TECHNICAL DEFICIENCIES RESPONSE LETTER

June 10, 2024

***Re: Technical Deficiencies Responses for the Phase IV Pipeline
DEP Joint Permit File No. E4129223-006 / APS No. ID No. 1096604***

SHEET 2 OF 4

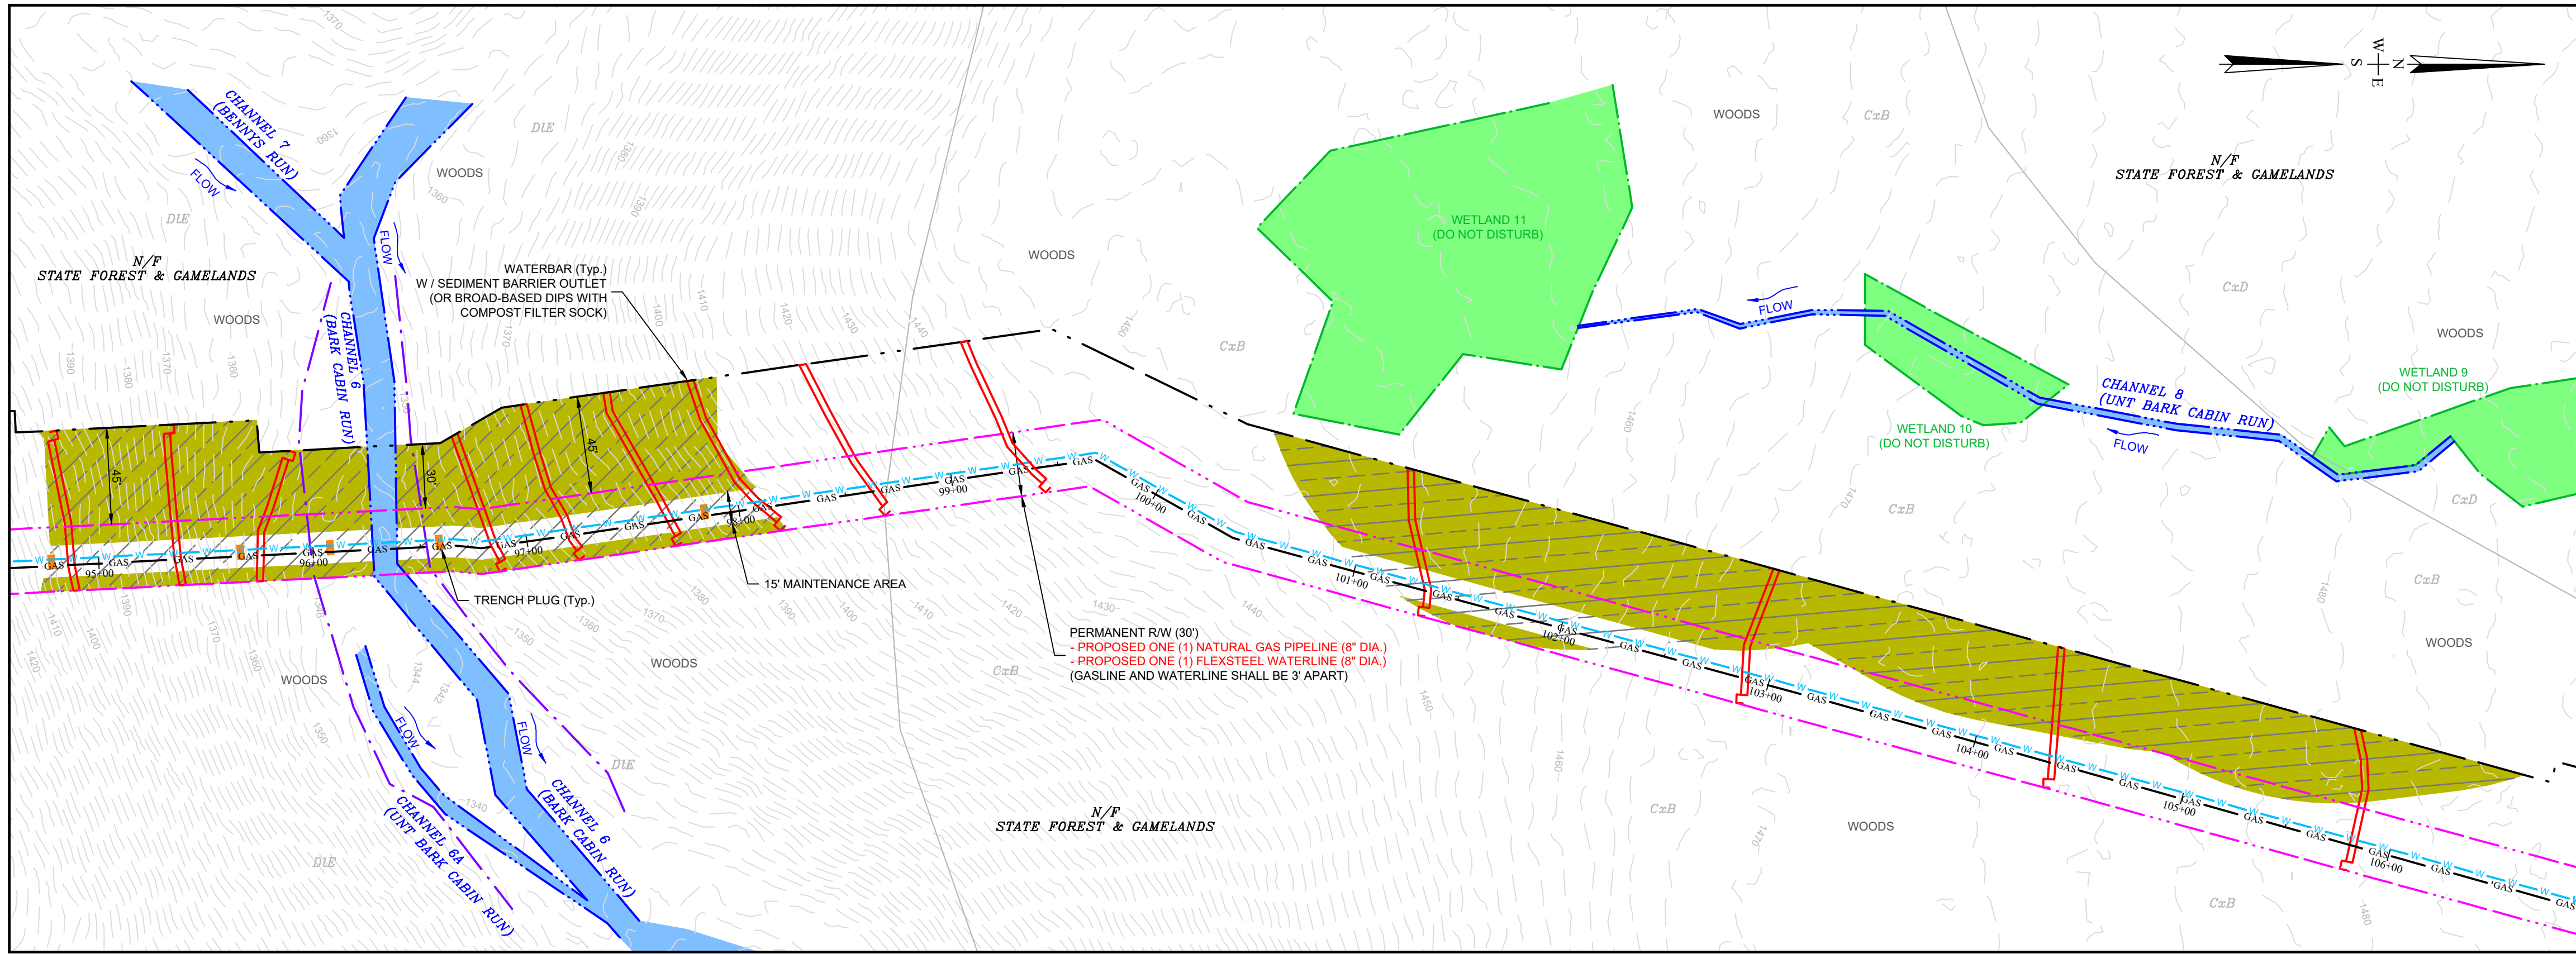
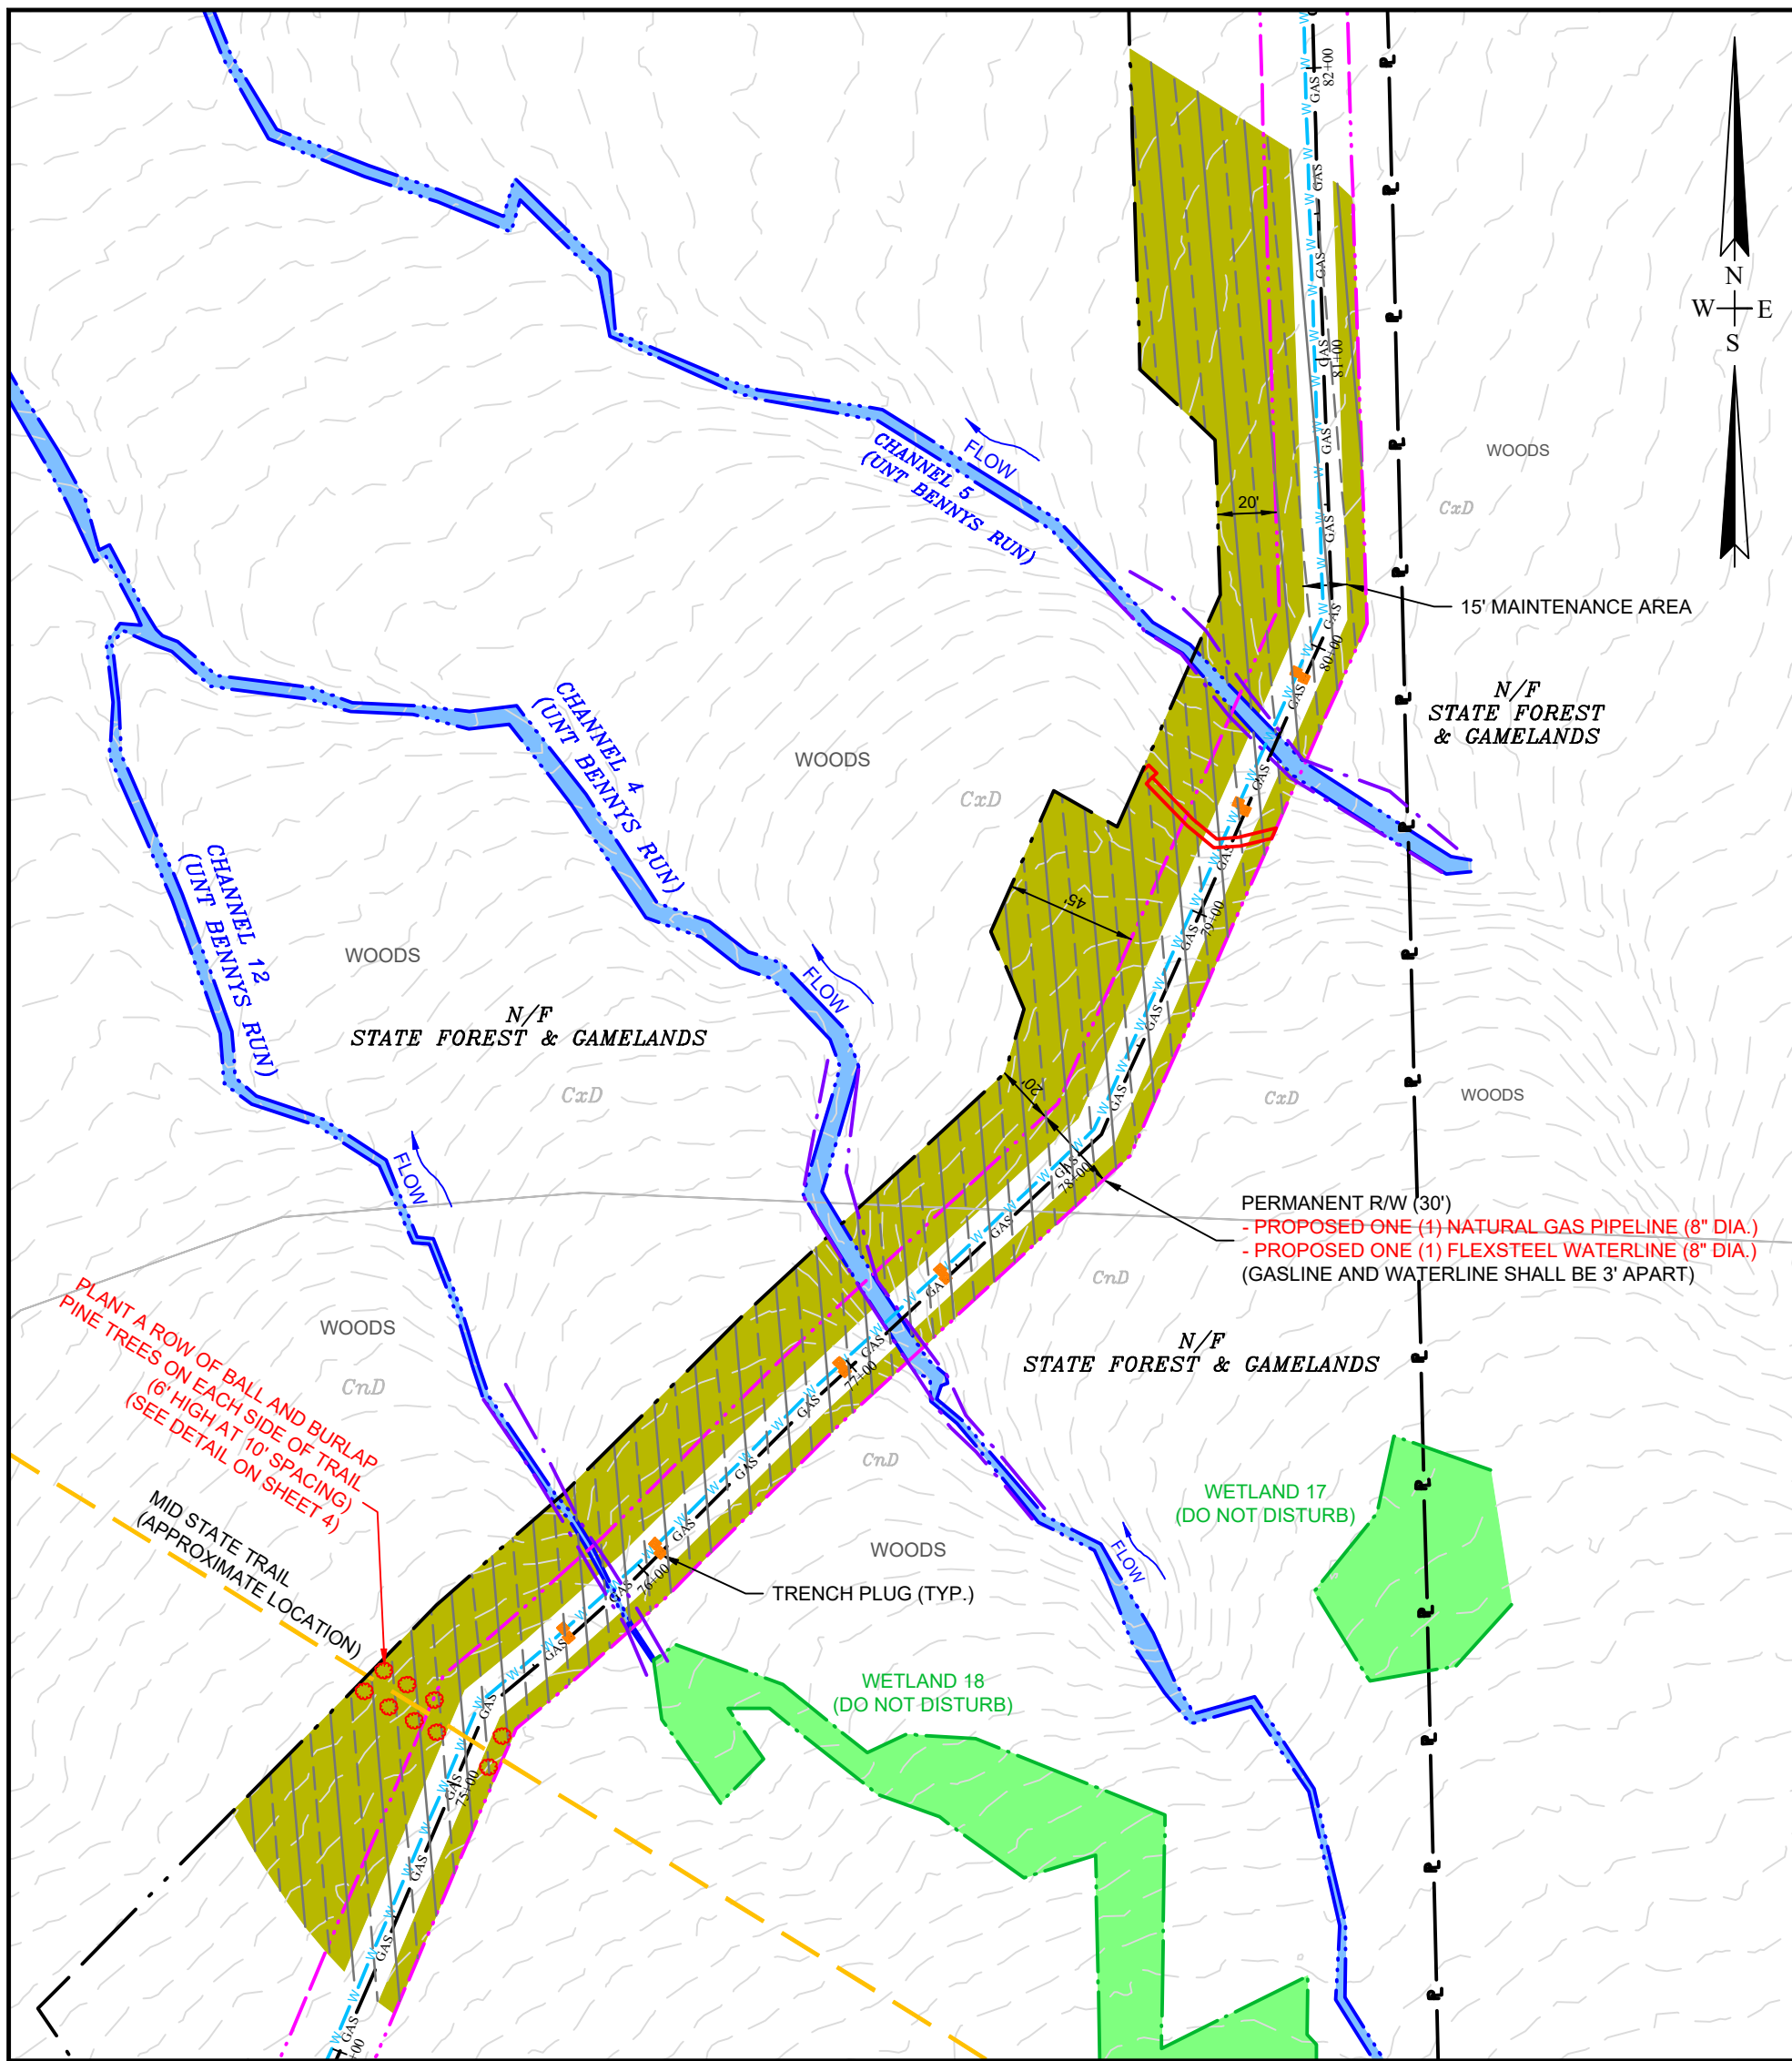
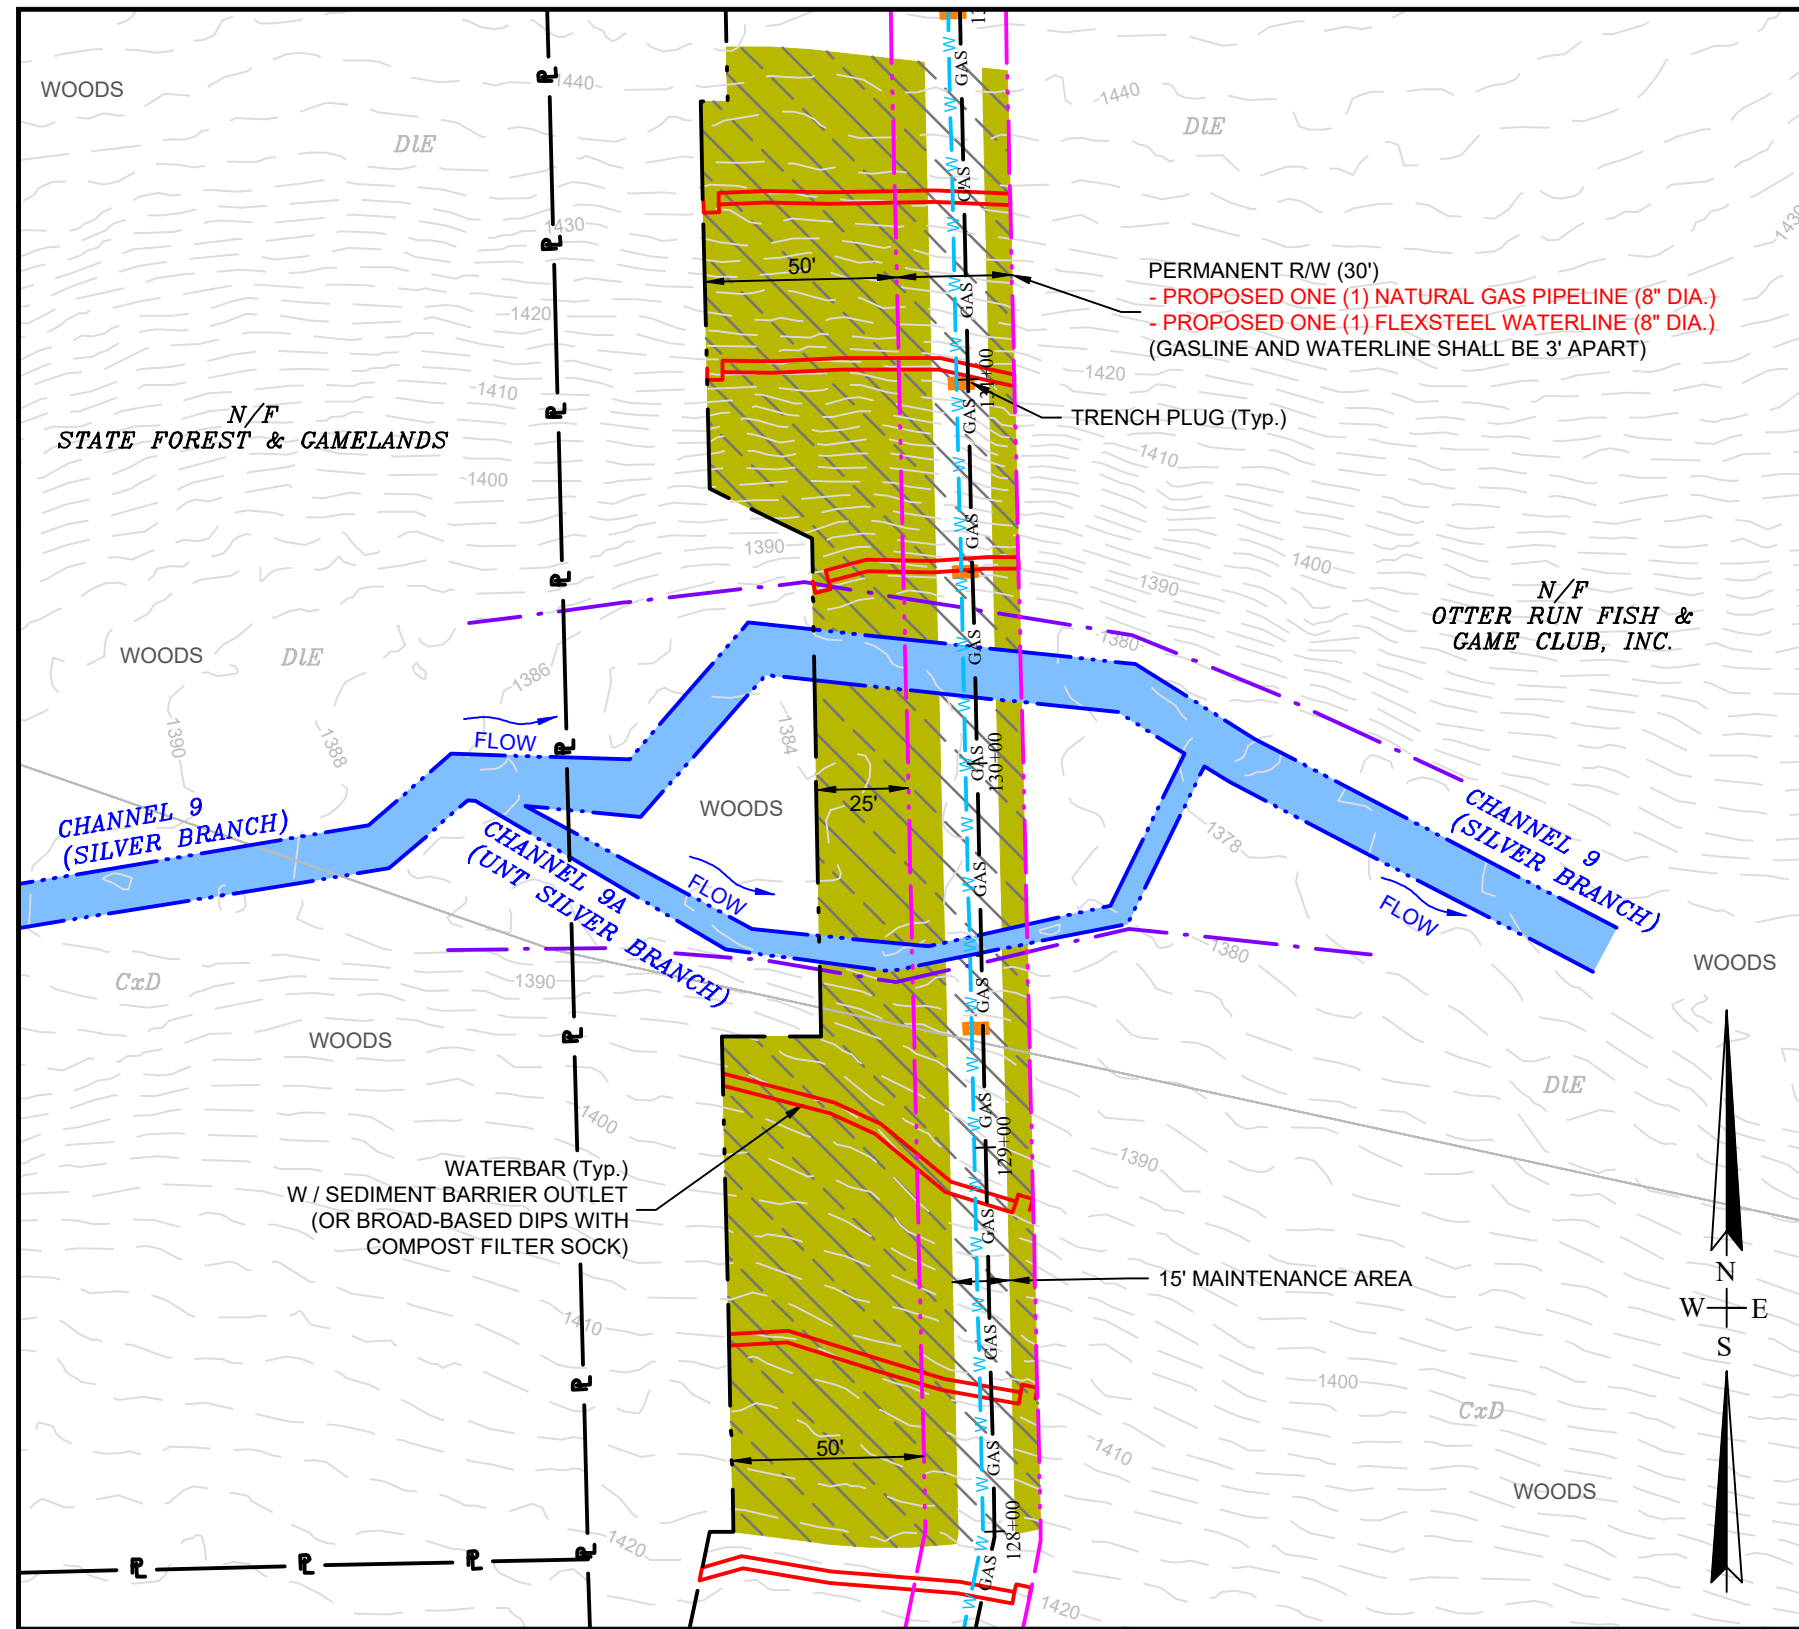
2. Provide protective measures (e.g.- tree tubes, fencing, enclosures, etc.) for proposed tree and shrub plantings (wetland and riparian areas) to help promote success and survivability. 105.13(e)(1)(ix)

The protective measures have been added to the notes on the Wetland & Riparian Buffer Planting Plan Sheets 2 & 3.

- Where local conditions warrant, these dates may be extended with the owners approval.
 8. To help promote success and survivability for proposed tree and shrub plantings (wetland and riparian areas), use protective measures such as tree tubes, fencing, enclosures, etc..
